NESTOR Shielding and Dosimetry Improvement Programme.

The ASPIS-PCA Slab Geometry Benchmarks.

RPSCD4038

CORRIGENDA TO AEEW - M 2329

Figure 6.1 MCBEND model of the NESDIP 1 array

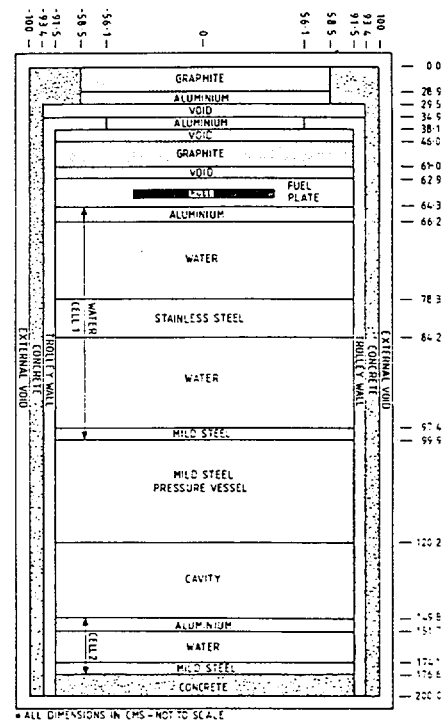
Figure 6.1 Distances from inside face of trolley front should change to
... 66.2, 78.3, 84.6, 97.8, 100.3, 120.6, 150.2, 152.1, 174.5, 180.0, 200.0

Figure 6.2 MCBEND model of the NESDIP 2 array

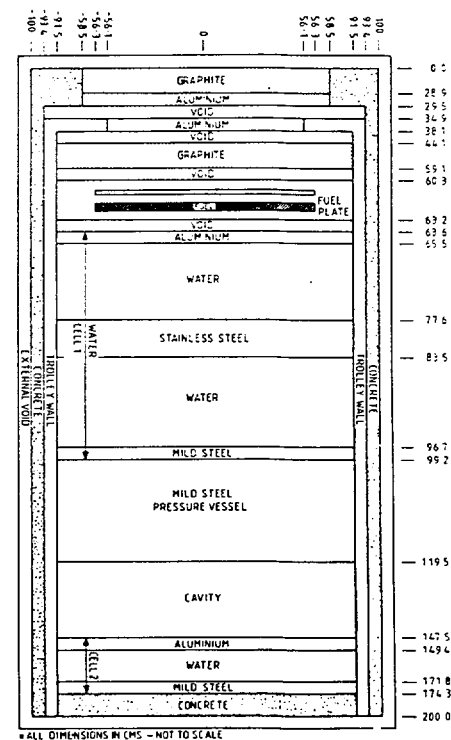
Figure 6.2 Distances from inside face of trolley front should change to
... 65.5, 77.6, 83.9, 97.1, 99.6, 119.9, 147.9, 149.8, 172.2, 174.7, 200.0
